## Addendum

Iowa Department of Transportation Office of Contracts Date Date of Letting: January 16, 2013 of Addendum: December 28, 2012

B.O.	Proposal ID	Proposal Work Type	County	Project Number	Addendum
102	57-3432-606	PCC PAVEMENT - GRADE & REPLACE	LINN	STP-U-3432(606)70-57	16JAN102.A01

Make the following change to plan sheet B.1:

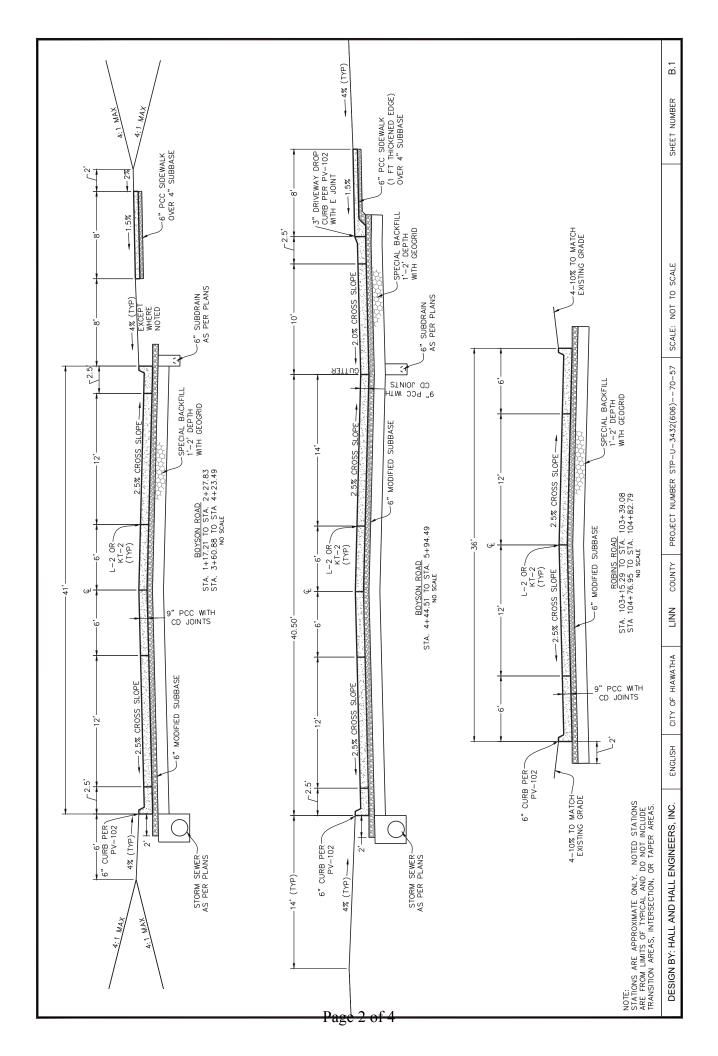
Replace plan sheet B.1 with attached plan sheet B.1
